TO: Jerry Davidson, Goode Perception Design Group
FROM: Elizabeth Steward, Associate Planner- Development Review
DATE: 5/12/26
SUBJECT: Parker Pointe F1 AMD 1 L3A - Huntington Bank

Staff Comments 02
SP25-138; Parker Pointe F1 AMD 1 L3A - Huntington Bank
Site Plan
May 12, 2026

LOT 3A PARKER POINTE SUBDIVISION FILING NO. 1, AMENDMENT NO. 1 HUNTINGTON NATIONAL BANK

APRIL 10, 2026
 SHEET TITLE
LANDSCAPE PLAN
 4 OF 10

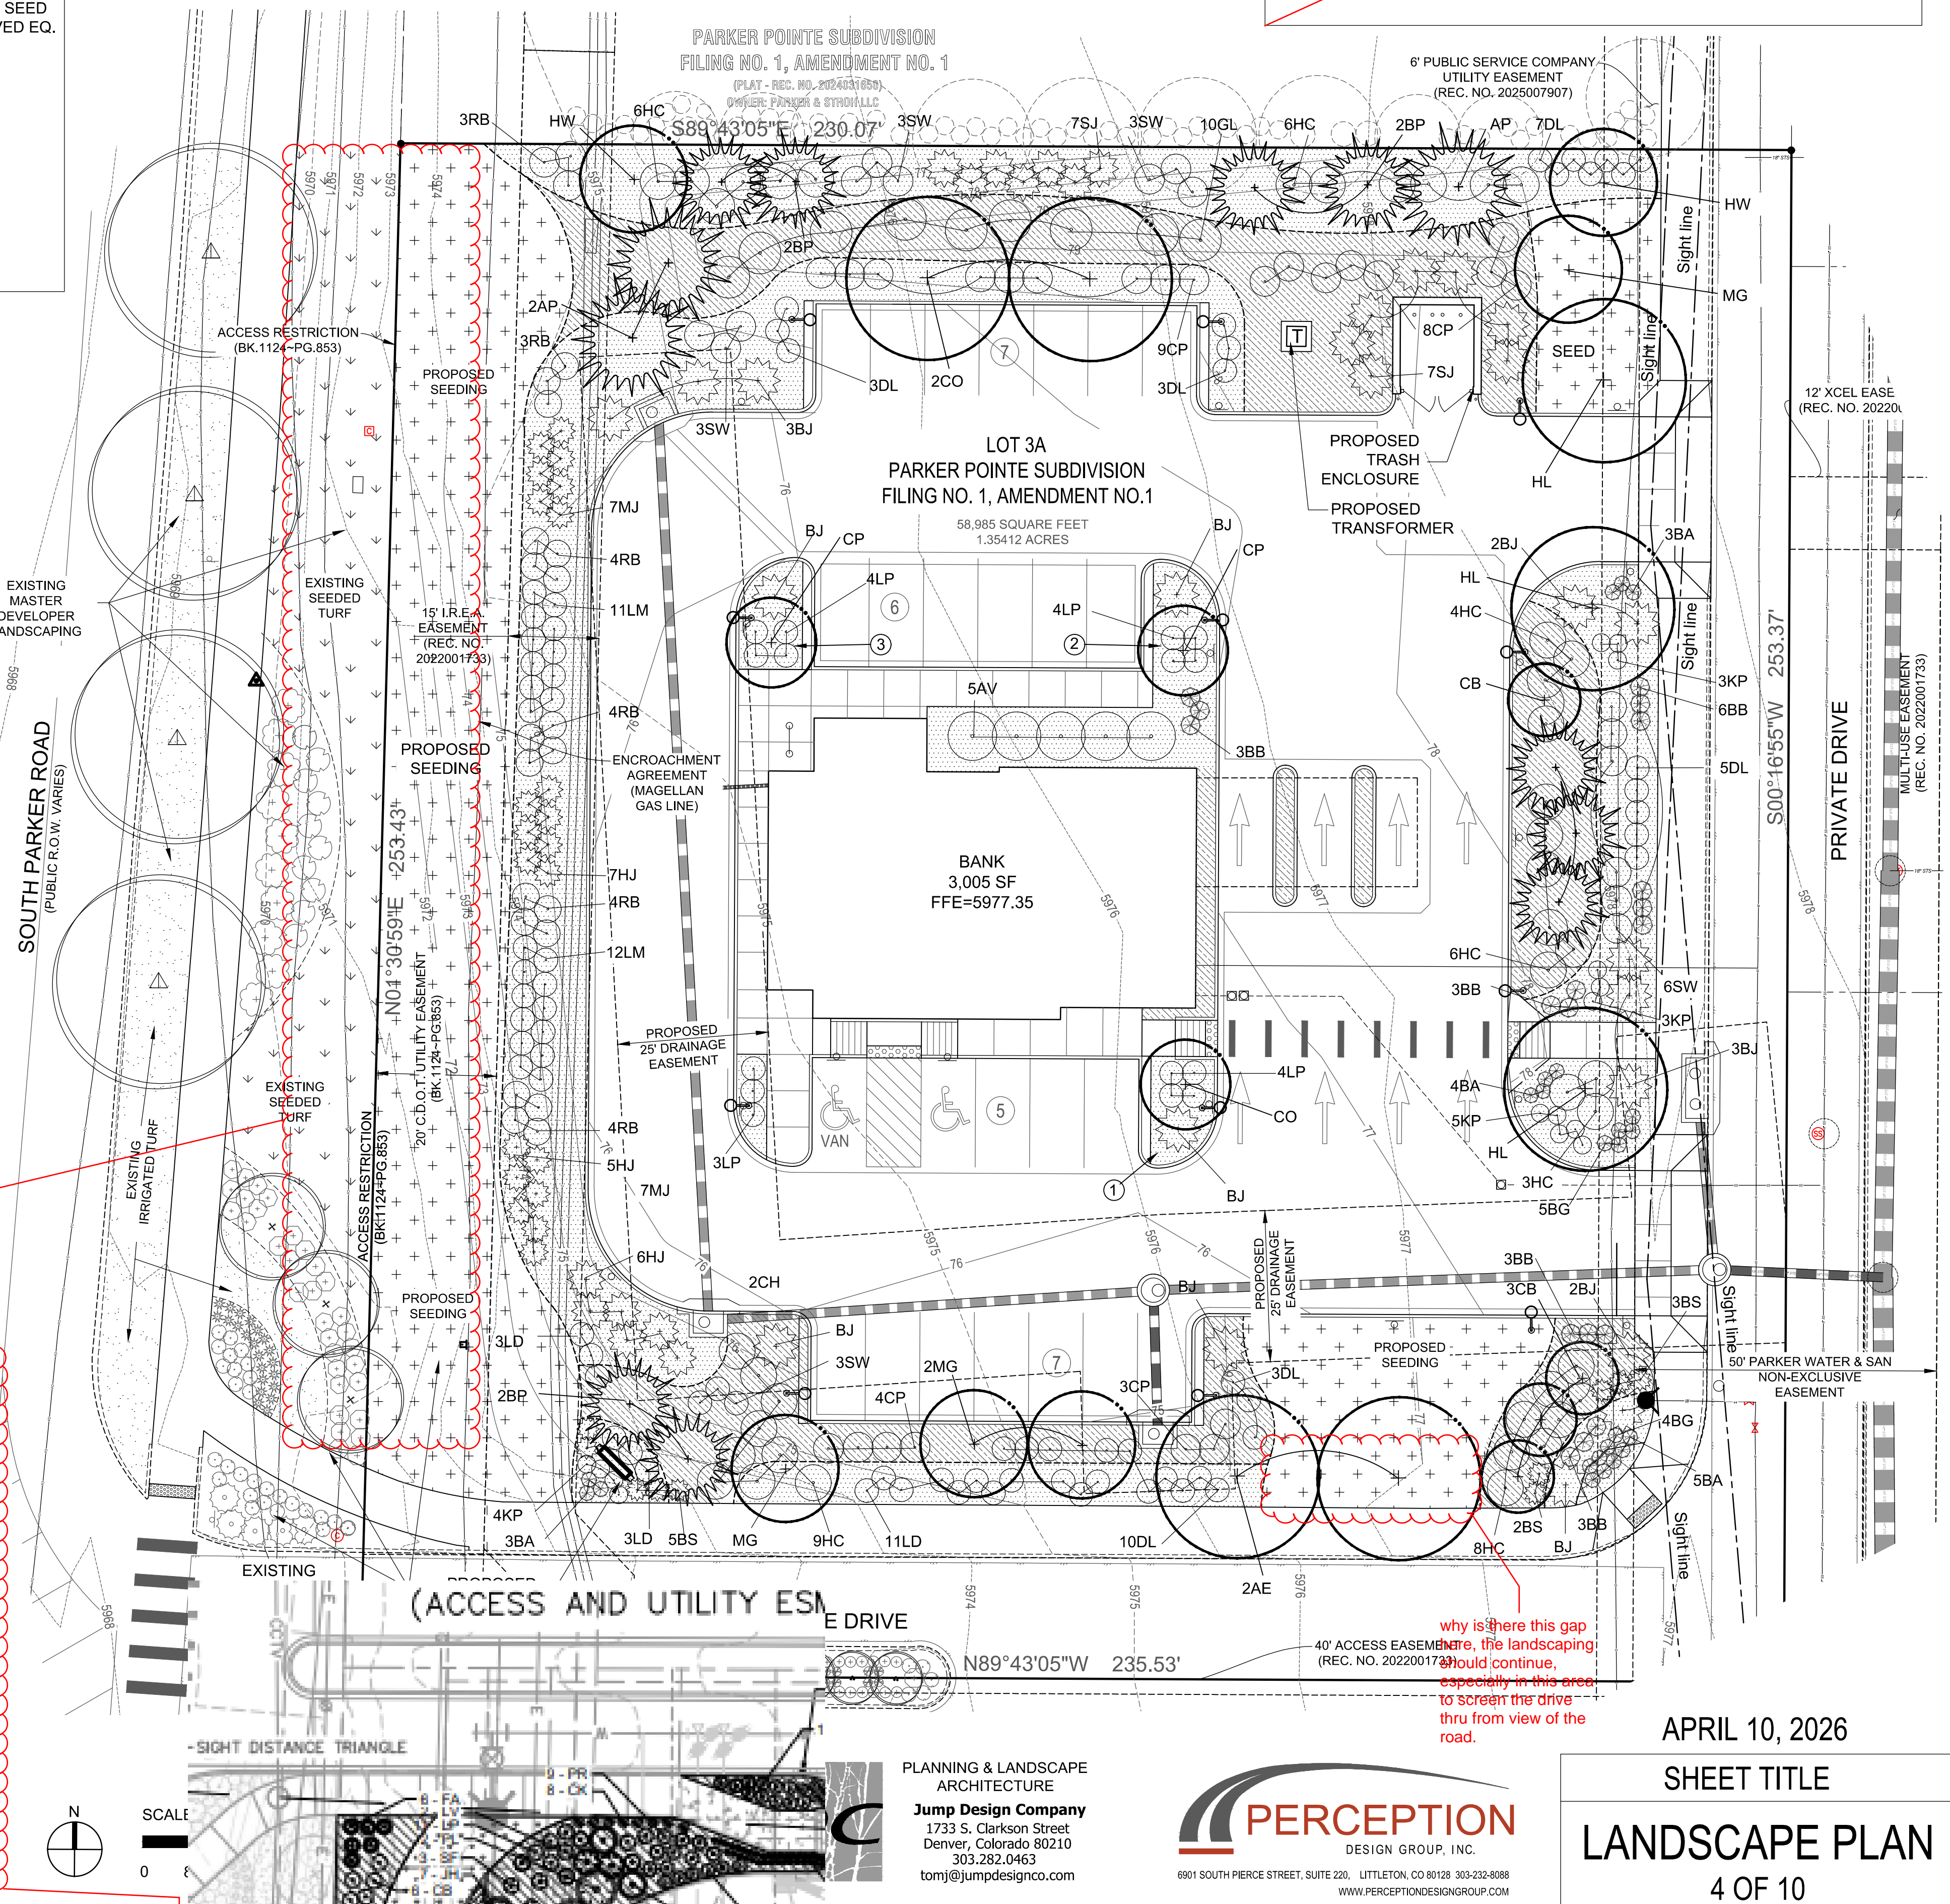
- Please move the Town Notes and Parker Standards to a new page and increase the size of the landscape plan. Currently very hard to read with the amount of material on one page.**

- Please address the gap in the landscaping along the private drive, the landscaping here should continue especially in this location to provide screening for the drive thru from the road.**

3. The Perimeter buffers were incorrectly interpreted on the last review. Pursuant to the LDO Section 13.08.090 (g) site perimeter landscaping is required to establish minimum requirements for plantings around the perimeter of a site. When an Commercial use is next to ROW, the P2 Moderate Site Perimeter landscaping requirements shall be satisfied. 3 sides, the South, East and West have a P2 Site Perimeter Landscape buffer requiring a 10 foot planting area width with 1 tree per 25 linear feet, and 5 shrubs per 25 linear feet, with a 25% evergreen tree requirement. The needed numbers to meet this have been listed on the redlines. Please add this requirement and the proposed landscaping to the landscape table.

4. To match the standards set for the subdivision, please add additional landscaping, grasses, perennials, and shrubs, along and at the property line and in the streetscape area. Snips of the above Black Rock Coffee and below McDonalds have been provided and aligned in the redlined landscape plan to show the standard that needs to be met. Note on first review stated that buffalo Blue Gamma grass has been added to match McDonalds, but additional plantings still need to be added in this space as it is directly on parker road and McDonalds has set the standard for the subdivision. The amount of seeded area should be reduced.

Does not have to be on final set, or can be moved to next page if want to keep

Comment on adding grasses refered to additional plantings in this area, similar to how mcdonalds minimized the seeding area to the maximum extent possible.

Apologies, I made an incorrect statement before, these are actually P2 required buffers as they are adjacent to ROW. They will require a 10 foot planting area with 1 tree and 5 shrubs per 25 linear feet, with 25% required evergreen.

SHEET TITLE
BUILDING ELEVATIONS
7 OF 10

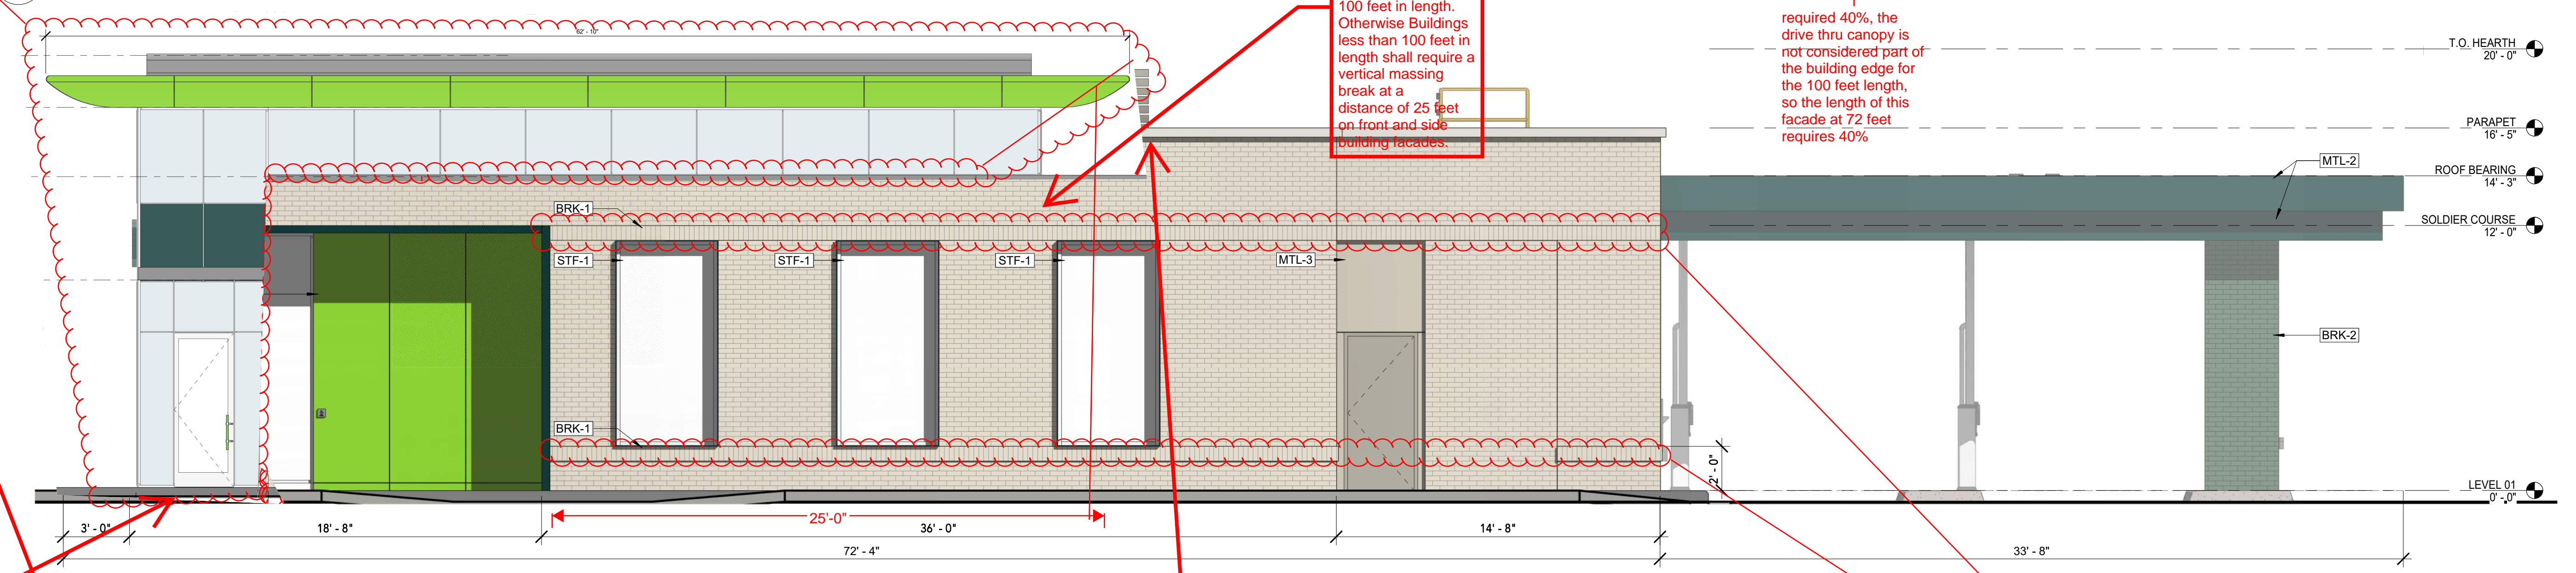
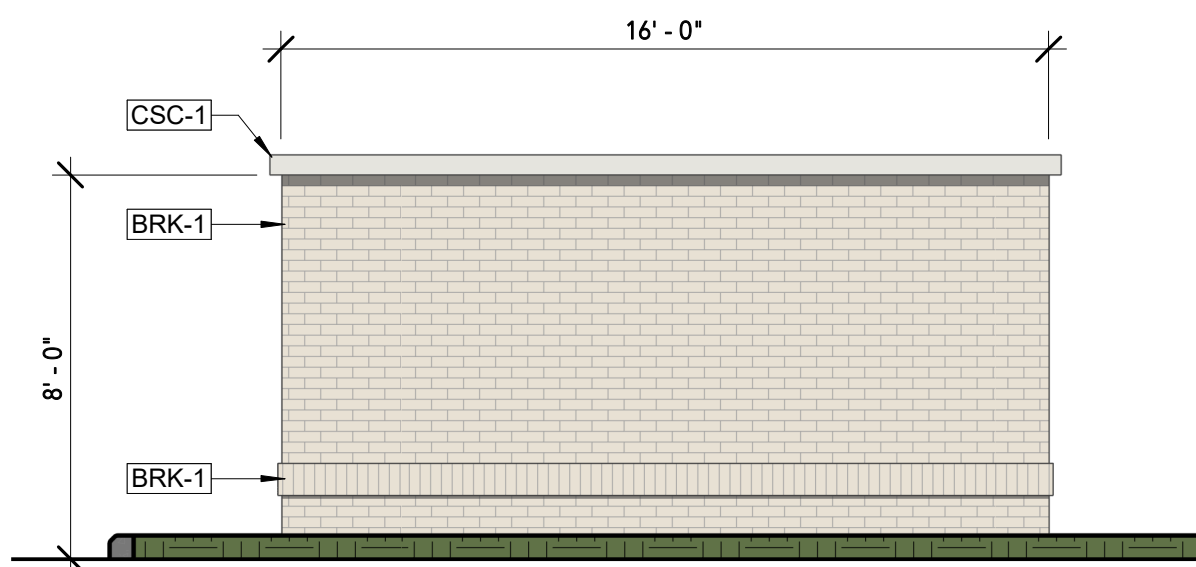
1. The previously submitted elevation included a more transparent glass tower feature at this corner location. The currently proposed design substantially reduces the glazing and visual prominence of this architectural element. Staff did not provide prior comments requesting modification of this feature. Consider reinstating the previously shown tower glazing and corresponding side elevation treatment to increase transparency, strengthen the architectural corner feature at the intersection of Parker Road and Napa Avenue, and provide additional roofline variation and articulation. The earlier design better emphasized the corner condition and contributed additional visual interest along both street-facing elevations.

2. Removal of the tower/roof feature reduces the vertical massing variation previously provided on this elevation. Buildings less than 100 feet in length are required to provide a vertical massing break at intervals of 25 feet along front and side facades. The current elevation may not clearly demonstrate compliance with this requirement. Reinstating the previously proposed tower feature could help satisfy the required plane and massing break; alternatively, another architectural element or façade modulation meeting the intent of the standard may be provided. Applicable standards include: “Buildings less than 100 feet in length shall require a vertical massing break at a distance of 25 feet to front and side building facades.” and “Integrate varied roof lines, modulated building heights, stepbacks, or innovative architectural detailing.”

3. The south elevation may not currently demonstrate the minimum required architectural elements along a façade facing a public roadway. Please provide a response in the comment memo identifying which qualifying architectural elements are being utilized to satisfy this requirement, or revise the elevation accordingly.

4. The south elevation is considered a front building façade and is therefore subject to the required 40% transparency standard. The drive-thru canopy should not be included as part of the building edge when calculating façade length. Excluding the canopy, the south façade measures approximately 72 feet in length and is therefore subject to the transparency requirement applicable to façades less than 100 feet in length. The currently provided transparency calculation of approximately 32% does not appear to meet this requirement. Please revise the elevation accordingly or provide additional justification in the comment response memo.

6. The south elevation currently appears to be the only façade that does not incorporate the green brick material utilized elsewhere on the building. Staff recommends incorporating the green brick on this elevation to maintain consistency in materials and architectural composition across all building sides, particularly along the façade containing the primary entrance. Utilizing the material as a soldier course or similar accent/detailing element would be an acceptable approach.

7. The primary entrance on the south elevation may not currently demonstrate compliance with the required entrance articulation standards. Please revise the elevation or provide additional justification in the comment response memo demonstrating how the entrance meets the applicable design requirements.

Why was this elevation so significantly changed? Staff had no comments on this side, it and the corresponding side view of this tower feature could be added back in the increase transparency and provide a corner feature for the side facing parker road and napa avenue

adding back in this roof feature here would count as a roofline change for the required vertical massing break at 25 feet for building facades less than 100 feet in length. Otherwise Buildings less than 100 feet in length shall require a vertical massing break at a distance of 25 feet on front and side building facades.

considered a building front and will need 40% transparency for a building facade less than 100 feet in width. Can be substituted with murals beyond the 2 to 8 foot range for alternative compliance-based on next page a mural of 118 sqft will be added, please add that to this table to show that the 40% area for transparency through alternative compliance is met

c. Each entrance shall have a weather-protection covering with an awning, overhang or canopy.
d. Entrances shall be articulated architecturally by (see figure 83):
i. Vertical breaks in the massing
ii. Breaks in eave lines and roof forms
iii. Awnings
iv. Canopies
v. Arcades
Individual storefronts shall be distinguished by a minimum three (3) of the following list of design features at the ground level (see figure 84):
i. Lighting fixtures (full-cut off)
ii. Bulkheads
iii. String courses
iv. Piers or pilasters
v. Storefront cornice
vi. Tile work
vii. Masonry
viii. Awnings
ix. Transom windows

Varying roofline on all 4 sides is required per development design standards, adding back the tower feature would satisfy this

use green brick here for soldier trim to use all building elements on each side; this is the only facade lacking the green brick and it needs to be carried over. This needs to be included on the side with the main entrance

SHEET TITLE
BUILDING ELEVATIONS
8 OF 10

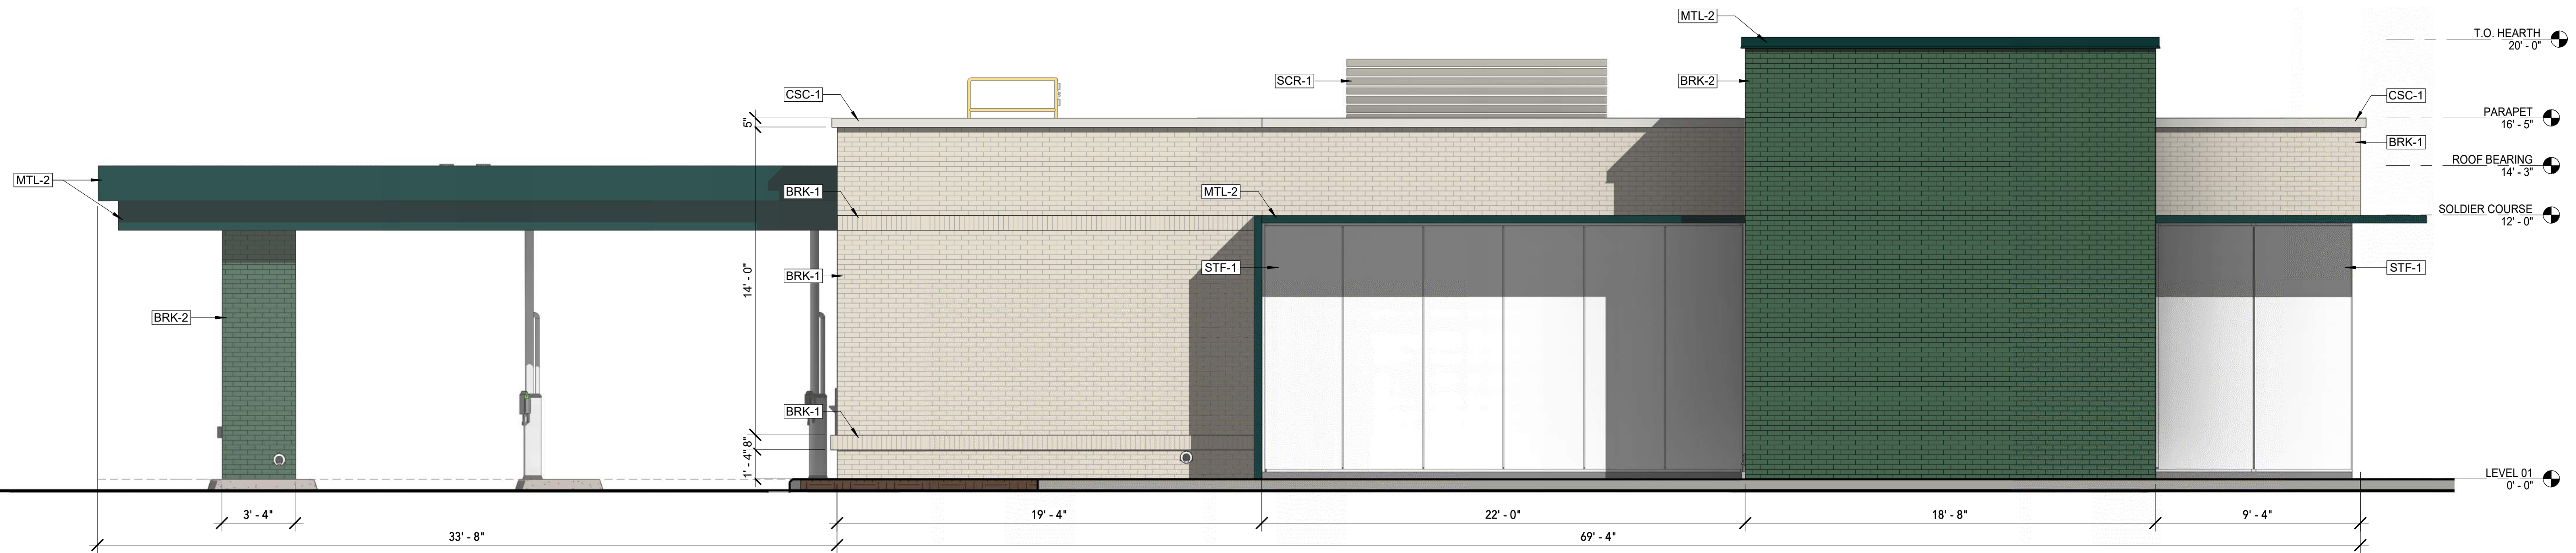
5. The east elevation is considered a front building façade and is therefore subject to the required 40% transparency standard for façades less than 100 feet in width. Transparency may be supplemented through alternative compliance measures, including murals located outside the 2- to 8-foot transparency zone. Based on the following sheet, an approximately 118-square-foot mural is proposed. Please include the mural area within the transparency calculation table to demonstrate compliance with the required 40% transparency standard through alternative compliance measures.
